TO: DEVELOPMENT REVIEW BOARD **DATE:** July 10, 2003
FROM: CURRENT PLANNING SERVICES
SUBJECT: CASE 18-DR-2001#2
REQUEST: Approve site plan & elevations for a 3-story office building
PROJECT NAME: Scottsdale Corporate Center Phase I
LOCATION: South of the SWC or Pima & Bell Roads

DEVELOPER/OWNER: Hines
ARCHITECT/DESIGNER: Kendall / Heaton Assoc., Inc.
ENGINEER: Paul-Koehler Consulting
APPLICANT/COORDINATOR: Hines Interests Limited Partnership/Chris Anderson
2375 E Camelback Rd Ste 790
Phoenix, AZ 85016
(602) 385-6917

REQUEST: Re-approval of site plan and elevations for a 102,549-sq. ft., three story office building plus parking structure.

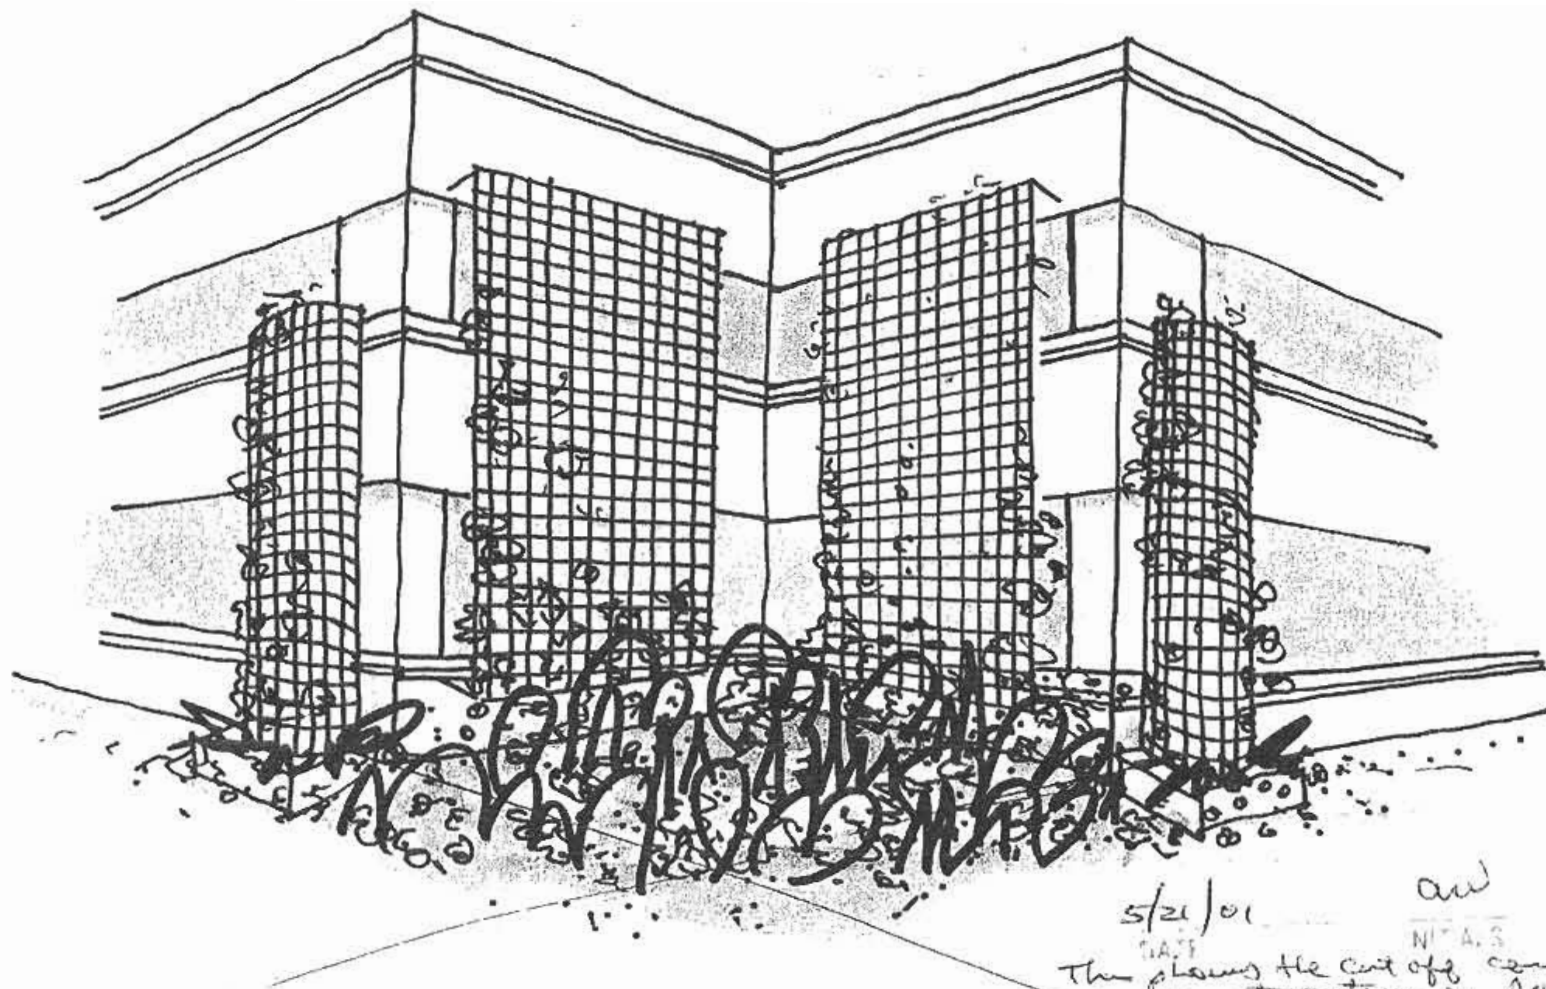
The drawing shows the cut off corner of
 the parking structure as presented to
 the DCS by the applicant
 at the DCS & supported by the Board
 10-22-01

FOR LARGER SITES, AN ADDITIONAL ENCLOSURE SHALL BE REQUIRED FOR EACH BUILDING SPACE INCREASE UP TO 20,000 S.F., AS SHOWN ABOVE. NEEDS 5 REFUSE ENCLOSURES; SITE PLAN ONLY SHOWS ONE.
